UNITED STATES PATENT AND TRADEMARK OFFICE

APPLICATION NO.	FILING DATE	FIRST NAMED INVENTOR	ATTORNEY DOCKET NO.	CONFIRMATION NO.
10/760,075	01/18/2004	Frederic Fortin	PUS-H002-001	1916

Office Action Summary	Application No.	Applicant(s)	
	10/760,075	FORTIN ET AL.	
	Examiner	Art Unit	
	Nicholas Woodall	3733

DETAILED ACTION

Figure 2

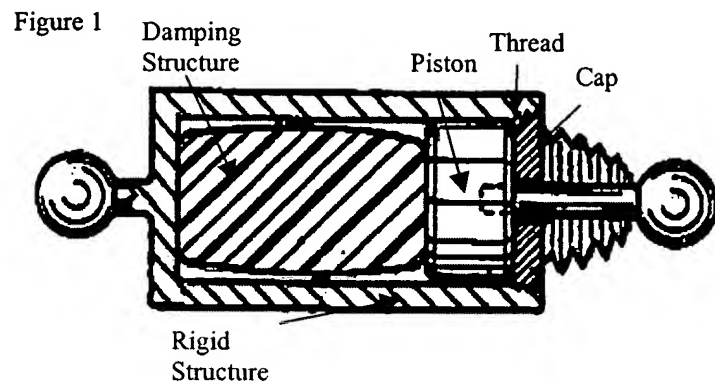
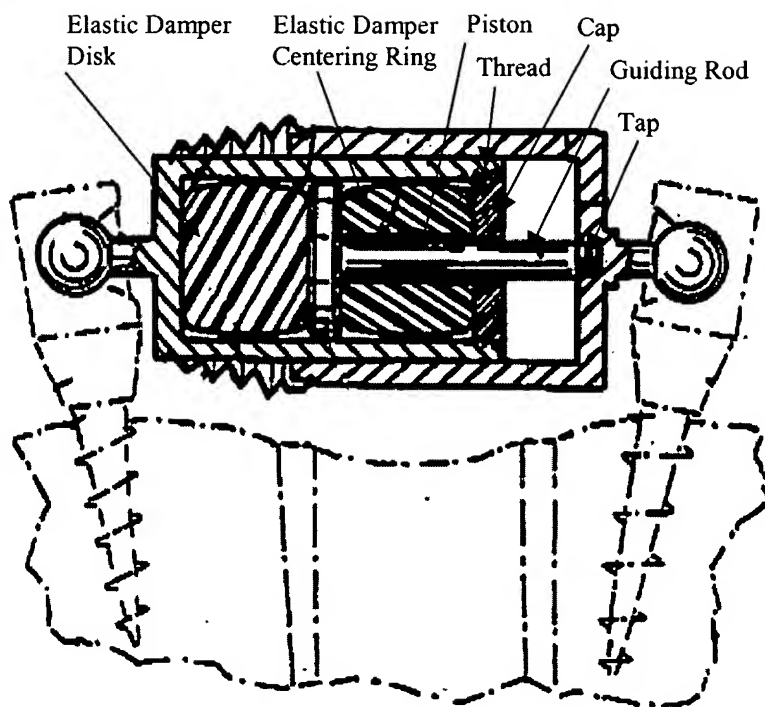
Regarding claim 8, Navas teaches an implant characterized in that the mechanical structure means is equipped with a thread and comprises a cap with an orifice that is designed to fit the diameter of the guiding rod of the piston as shown below in Figure 2.
